Edits Made to TSI Rev.6 Board for Next TSI Revision

Note: things in red are unresolved.

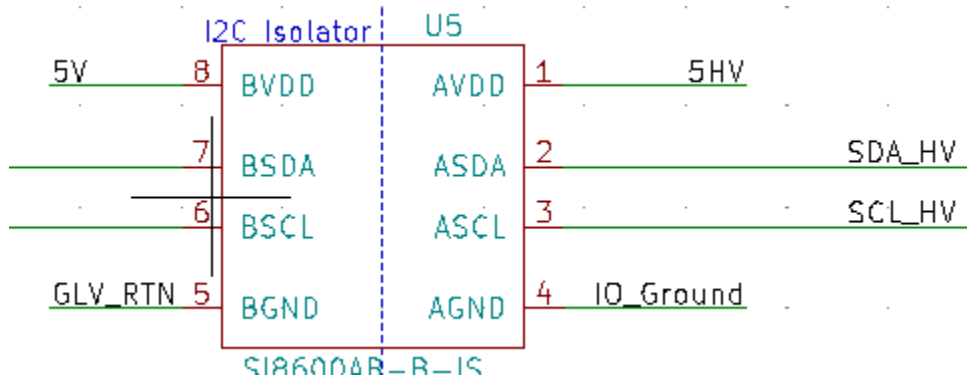
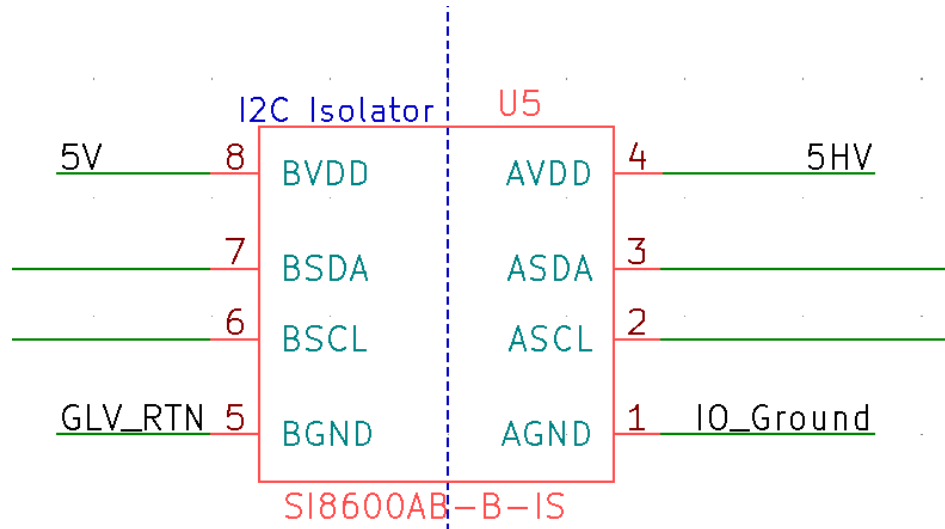
1. MC_95% Signal should actually be PC_Control as seen below, flywire needs to be added to board. This is an artifact from TSI Rev. 4's board. They had two separate pre charge ready signals, they were "Precharge Ready" and "Pre charge Ready." We thought this was a mistake and removed the "pre charge Ready" signal from the schematic. Thus leading to the current confusion. (edits made on TSI schematic and pcb schematic)

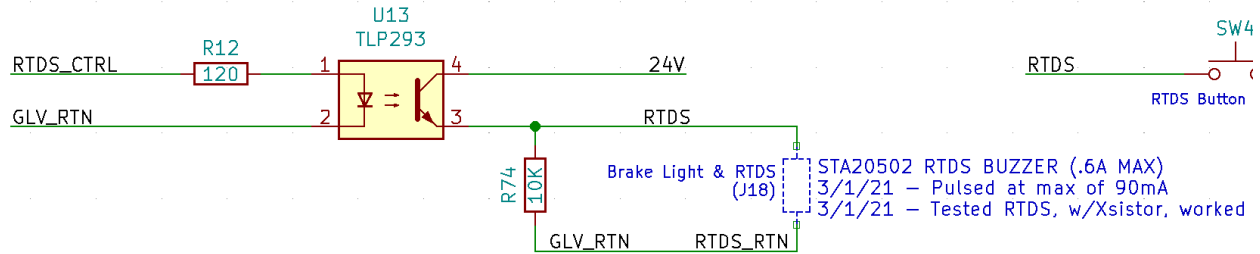
1. RTDS TLP (U13) gets very hot if RTDS is left on too long. Not an issue we were concerned with because technically RTDS should be only on for about two seconds. Could be remedied in later design.

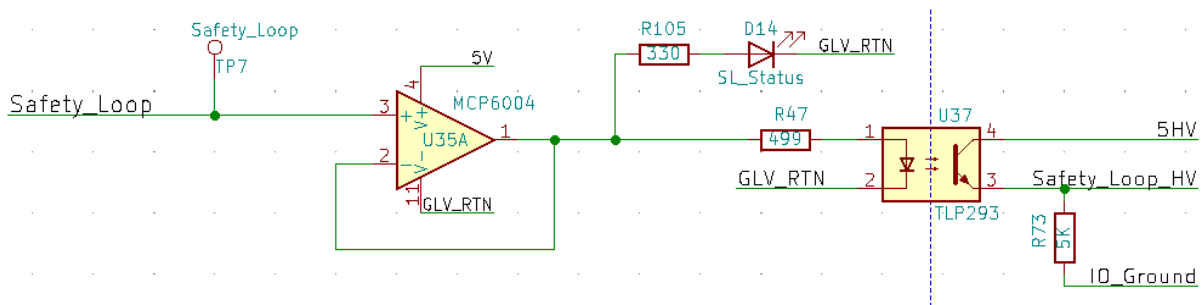
2. Changed U35A's rails from 3.3V to 5V

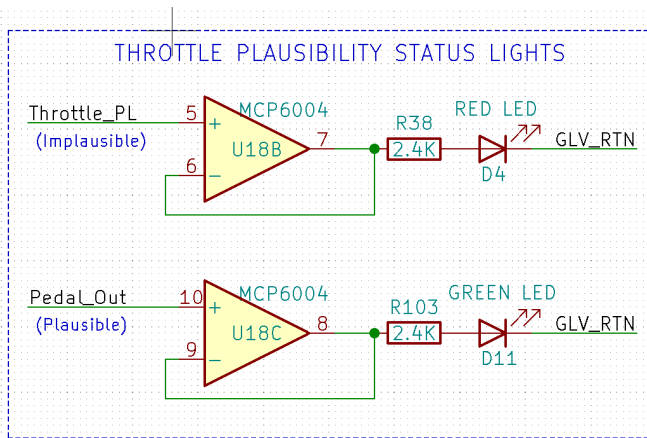
D4 on backwards or burned out. To drive D4 and D11, should not use the actual throttle_pl and Pedal_out signals. Example: as when pedal_out is around a volt (you're driving the throttle voltage of the motor) the LED doesn't come on.

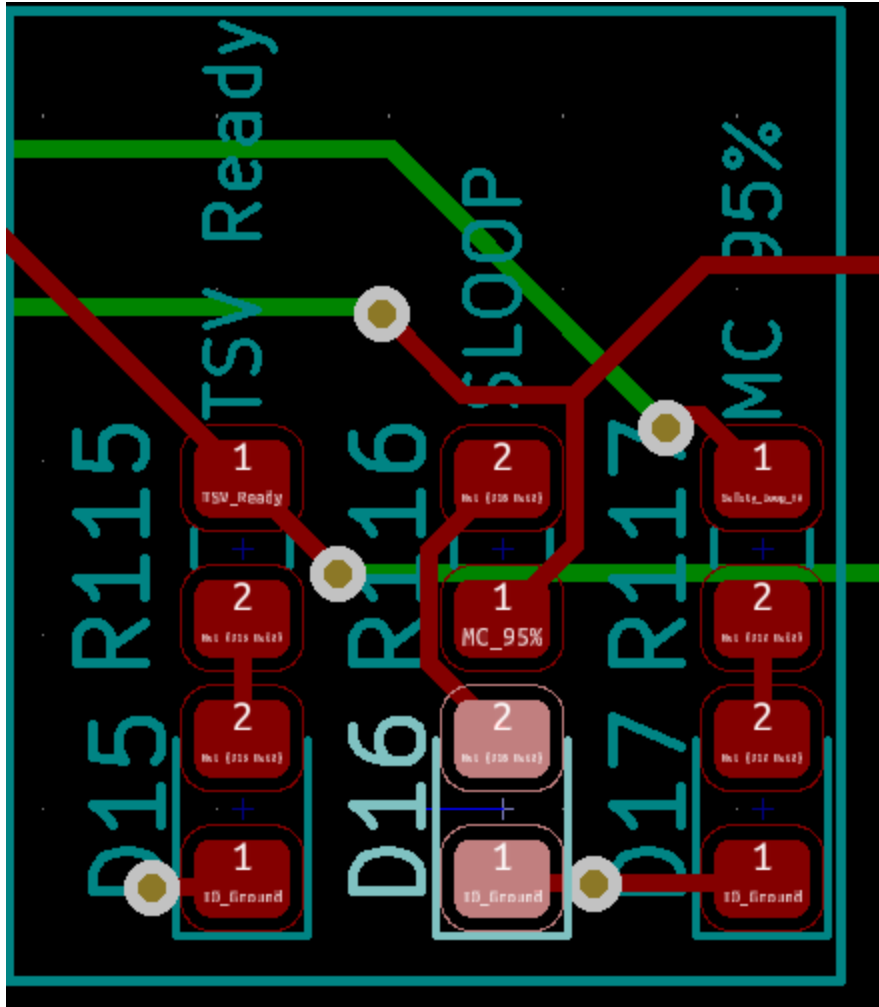
On the actual board, the silkscreens are flipped for D16 and D17. D16 is MC 95%, and D17 is SLOOP in actuality.
